Heritage Statement Addendum

7ABC Bayham Street, Camden

Figure 1: Proposed Bayham Street Elevation

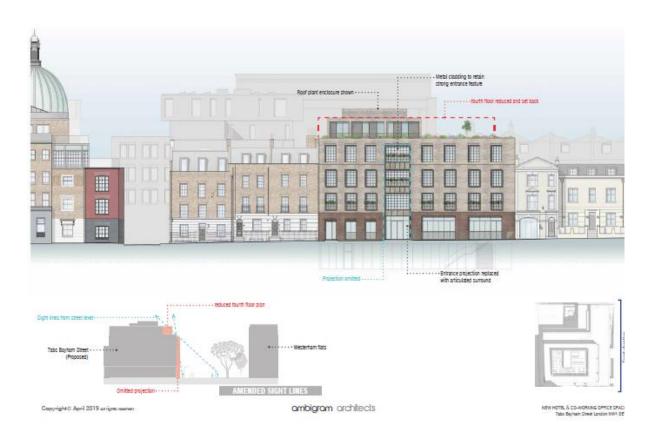
8. To enhance the appearance of the proposed front elevation on Bayham Street more detail has been incorporated into the design. In response to comments made by LB Camden the projecting central bay has been removed and metal cladding is proposed to draw the eye to the principal entrance of the building. This change

has increased its architectural interest, which continues to respond to both the industrial context of the existing site and the more contemporary style extensions to the south (as proposed at Koko and seen at Bayham Place).

9. Articulation has been provided to the fenestration of the building; this includes the use of metal detailing to provide a contrast with the brick elevations. This provides additional interest to the front elevation and responds to the light industrial character which informs the style of the proposed new building.
